Clarification on Partial Frames and LPI

William Lo

April 3, 2019

Figure 149-XXX Timing relationship to PFC24

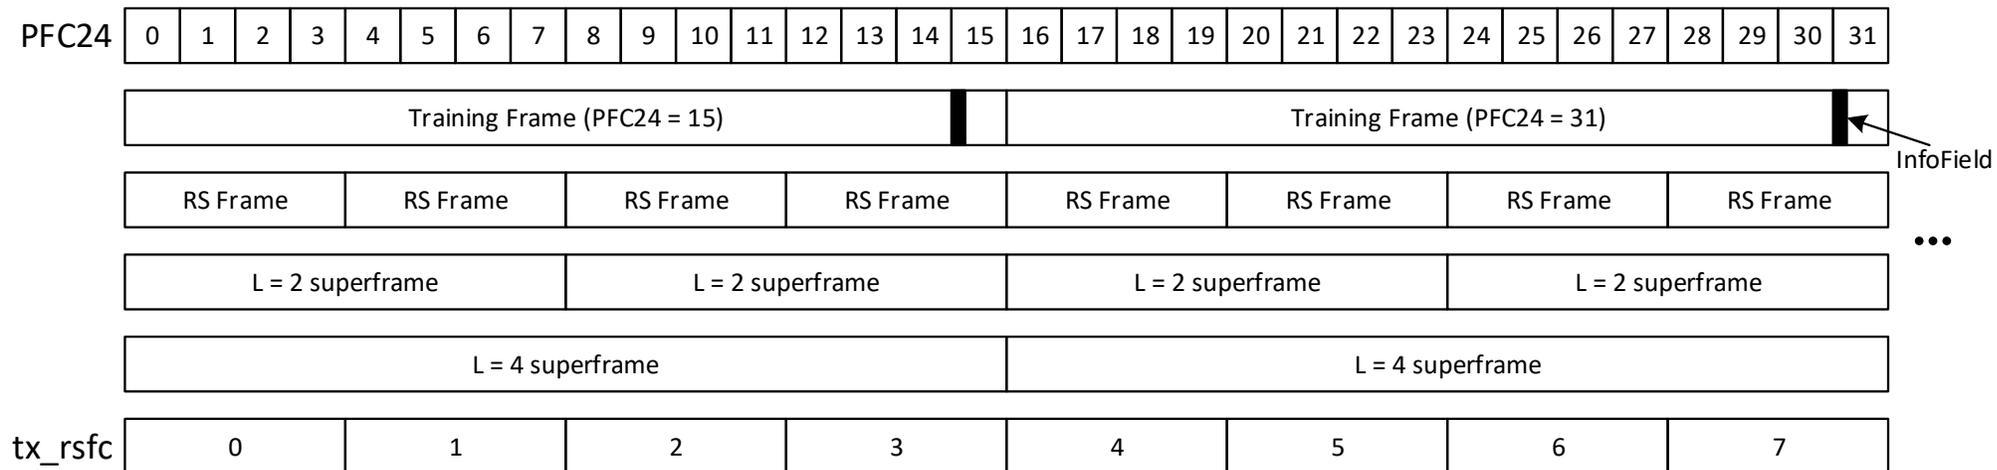
149.3.4.1 A figure is worth a thousand words

- Page 98 line 35 – add the following text

The timing relationship among training frame, partial frame, RS frame, superframe, PFC24, and tx_rsfc are shown in Figure 149-XXX.

- Page 98 line 41 – add the following figure

Figure 149-12—Timing periods for LPI signals

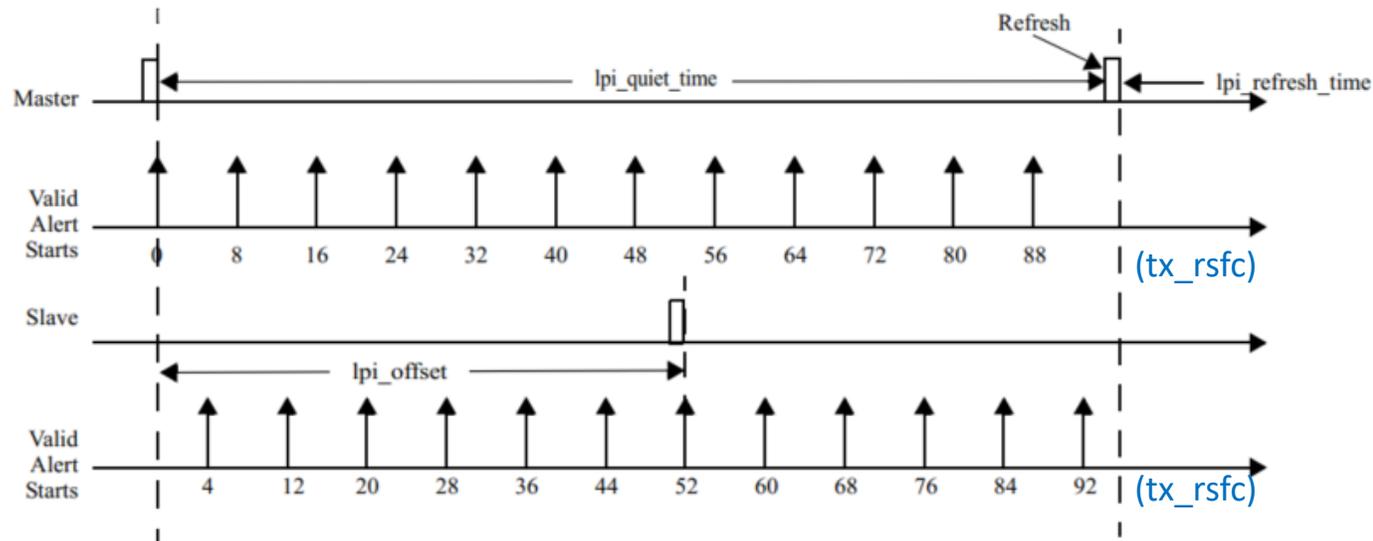
149.3.5 Changes

- Insert the tx_rsfc labels in Figure 149-12 to clarify what the numbers mean
